BELL IROQUOIS HELICOPTER MOCKUP

U. S. ARMY YHU-1D BELL IROQUOIS HELICOPTER MOCKUP EVALUATION Fort Worth, Texas 7 July 1960 19-20 January 1961

REPORT OF CRASH INJURY EVALUATION

Figure 2. YHU-1D proposed seating arrangement

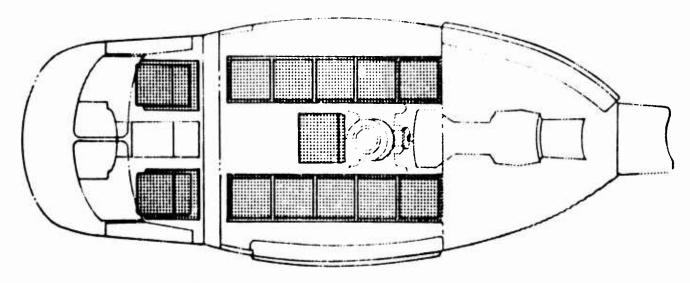
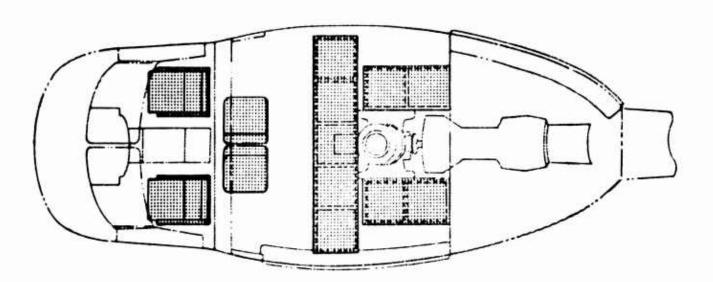
While emergency exit provisions in the basic aircraft appear to be adequate in size, number, and location, a serious problem is presented for the center seat occupant (forward of the pylon) if the seating configuration illustrated in Figures 2 and 23 is utilized. Evacuation would be even more critical should the aircraft come to rest on its side after an impact, in which case the troop seat occupants on the "low side" would also be in a very difficult position from which to emerge. For these reasons, the alternate configuration (Figures 3 and 25) is recommended.

- 4. The seating configuration shown in Figure 3 be utilized in preference to the proposed seating arrangement illustrated in Figure 2.
- 5. Crew seats, medical attendant seats, troop seats, and litter installations be dynamically tested to provide data which can be used as a basis for recommending changes to existing Military Specifications and structural design criteria.

Figure 7. YHU-1D right side, main cabin. Note rollover structure formed by vertical supports (carried through the roof structure).

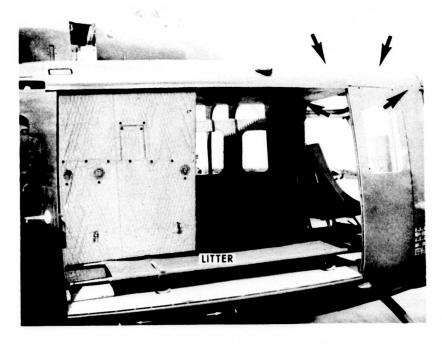
These vertical supports have been critical failure points in the HU-lA models (Figure 8) and have since been strengthened in the HU-lB. The supports for the YHU-lD are considerably larger and stronger units. By comparison with the door posts in the earlier models, which were not designed to carry any structural loading, the vertical supports in the YHU-lD are now designed not only to carry structural loading, but also extend up to the roof beams through a radius in the upper attachments to form, in effect, a complete roll-over structure.

The YHU-ID roof supporting structures appear to be designed with considerable improvement; however, the dynamic response, or the structural integrity, of the larger, heavier roof and proportionately stronger supports cannot be predicted with any degree of accuracy without subjecting these units to full-scale dynamic testing. It appears desirable, therefore, to subject these structures, in their planned configuration and structural relationships, to dynamic testing under laboratory conditions.

- b. The dynamic response, structural integrity, and ability of the larger, heavier roof to resist failure or deformation into the occupiable area of the aircraft.

Figure 10. YHU-ID fuel cell arrangement

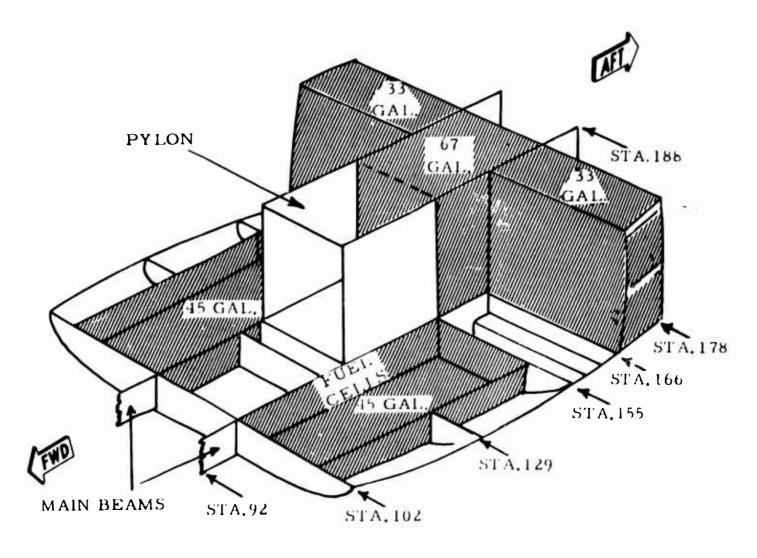
Due to the highly combustible nature of JP4 fuel, it is extremely important that the possibility of crash impact fuel cell rupture be prevented. Accident experience with the HU-1A helicopter has indicated that the aluminum honeycomb construction of fuel cells provides a good degree of impact protection against rupture and massive spilling. While post-crash fuel spillage or seepage has been noted in some of the HU-1A accidents, it has not generally been of such massive dispersement that potential fire ignition sources have come in contact with flammable fuel mist. With the redistribution of fuel cell location in the HU-1D, however, it would seem wise to carefully evaluate any new fuel spillage and post-crash fire hazards which may be introduced through such relocation, particularly with reference to fuel cells in the floor.

Although the external surfaces of these tanks will be provided with self-sealing (anti-ballistic) bladders, these static strength requirements are not compatible with even minimal crash force conditions which can be anticipated in impact conditions otherwise considered survivable.

- c. The ability of fuel cells, installed as presently planned, to resist puncture or spillage under crash force conditions, thereby creating potential post-crash fire ignition sources.

Figure 12. YHU-1D transmission support case mounts and support structure (top view)

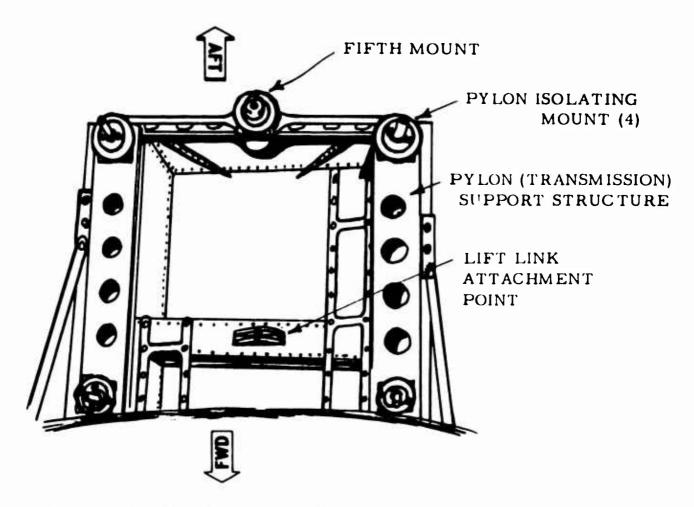
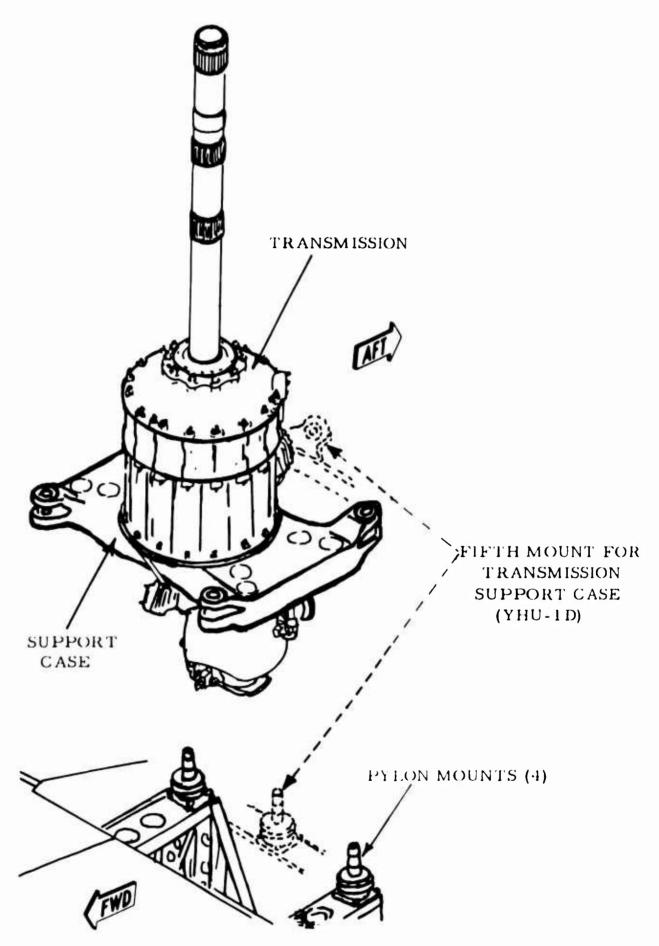
These repeated failures indicate an inherent weakness in the magnesium transmission support case.

In the YHU-1D, a greater mass must be supported by the same magnesium case because of the larger and heavier rotor system. It is questionable, therefore, whether the addition of the fifth mount will be effective in preventing failures such as experienced in the referenced HU-1A accidents. It appears that a solution to this problem would be to fabricate the transmission support case of welded ductile steel forgings, possibly stainless steel, which will yield progressively rather than shatter as in the case of the magnesium casting.

- 2. Consideration be given to replacement of the cast magnesium transmission support case with a newly designed type which would yield progressively rather than shatter. Consideration should be given to the use of materials such as ductile steel forgings, possibly stainless steel.

- 3. Consideration be given to the use of restraining cables attached to or encircling the transmission case and anchored to primary aft fuselage structure to prevent the transmission group assembly from penetrating into the occupiable area when subjected to impact.

Figure 19. YHU-1D engine, mounts (arrows A and B), and firewall (arrow C) - right side

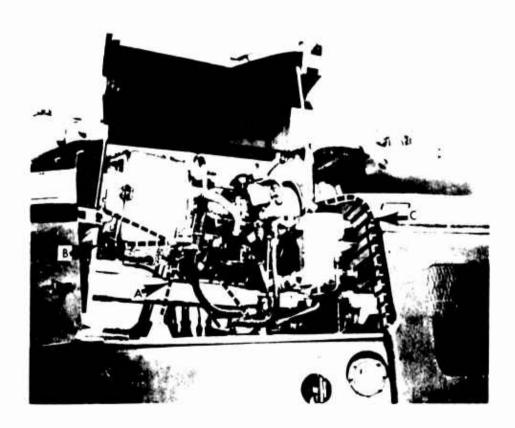
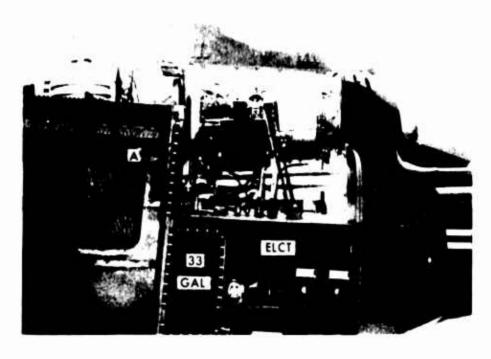
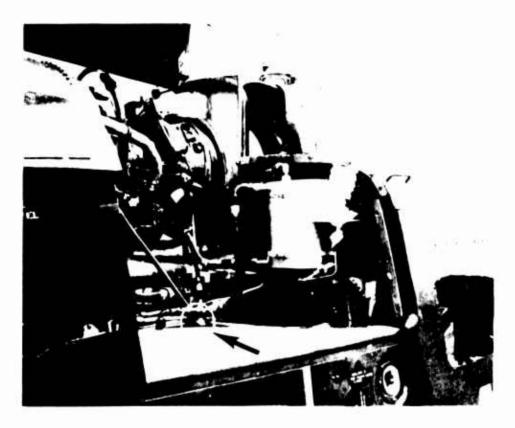
Although some engine mount failures occurred in the HU-lA accidents investigated, the failures were not significant from a crash injury point of view. In the YHU-lD, however, failures will be more significant because of the fuel cells located directly beneath the engine compartment.

Vertical impact loading by the engine sup ort system should be distributed over large areas where the supports are attached to the honeycomb deck structure above the fuselage fuel cells. Concentrated penetrating forces transmitted to the honeycomb structure can be reduced in p.s.i. loading by the use of large flat plate area mounting plates to reduce concentrated loading (Figures 19, 20, and 21).

- 4. Consideration be given to the use of large flat plate area mounting plates at the base of the engine mounts to reduce concentrated vertical loads transmitted by the engine through its mounts to the honeycomb structure over the fuel cells.

Figure 22. YHU-1D right side aft fuselage - heater compartment (1), and outboard 33-gallon fuel cell (2)

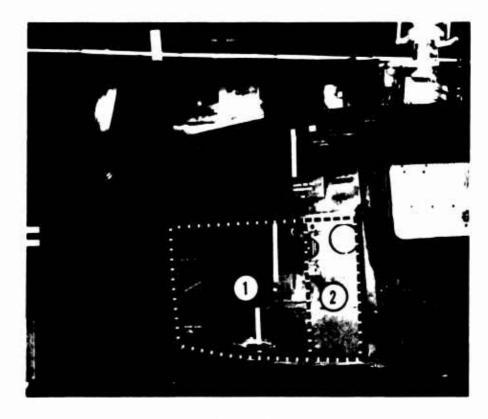
The proximity of the 100,000 BT J/HR combustion heater to the right outboard 33-gallon fuel cell (Figures 5 and 22) may constitute a fire hazard in the event of a crash. Although the heater exhaust is deflected up and away from the tank area, flammable fuel mists coming in contact with hot exhaust surfaces could present a dangerous post-crash fire ignition source. Likewise, "hot" electrical components on the left side, being in close proximity to the left outboard 33-gallon fuel cell, (Figures 11 and 20) may present similar potential hazards.

Although the combustion heater, electrical equipment, etc., are not considered in this category by Bell (failure of which would be apt to cause injury to occupants), they are potentially capable of inflicting injury or death in a less direct manner. These items, therefore, should be secured to withstand failure and possible fuel tank penetration resulting in post-crash fire under anticipated crash load conditions.

Figure 24. YHU-1D proposed troop seating configuration. Single seat (arrow) is essentially the same as the medical attendant's seat which is installed either forward or aft-facing in the center of the fuselage.

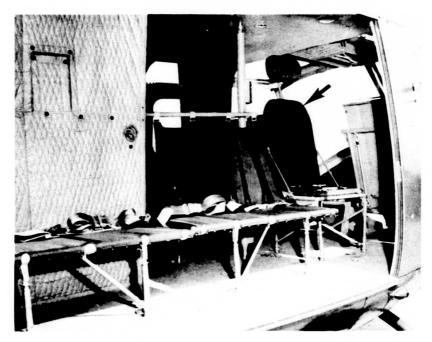
The medical attendant's seat in the YHU-1D (Figure 24) is a single seat located in the center of the cabin fuselage just aft of the flight crew station. Its floor mounts, unlike those in the HU-1A and HU-1B, are not rectangular but square, and may be anchored to the floor attachments in either a side, forward, or aft-facing position. This tubular metal seat provides a head-rest extending out from the seat-back on a single tubular support (Figure 24).

The restraint system with these seats consists solely of a seat belt. Because of their proximity to surrounding structure, occupants are exposed to injury of extremities, upper torso, and head in the event of crash impact accelerations. Thus, provision for additional occupant restraint in the form of chest straps or shoulder harness should be considered.

- 1. Pilot and copilot seats be subjected to a separate evaluation after their selection has been made.
- 2. Consideration be given to provision for additional occupant restraint in the form of chest straps or shoulder harness for the medical attendant's seat.

Figure 29. YHU-1D litter/seat support poles in overhead stowage. Arrow "A" shows snap fastener, arrow "B" shows pivoted anchorage.

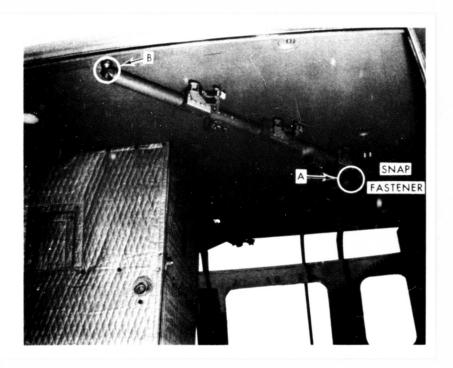
The proposed litter pole stowage (Figure 29) in the ceiling of the YHU-ID presents a potentially injurious env.ronmental factor, although such storage is not normally associated with troop or litter patient transportation. Positive restraint for stowed litter poles should be provided to a point that will insure positive retention (from flailing forward into occupiable area) under crash impact accelerations.
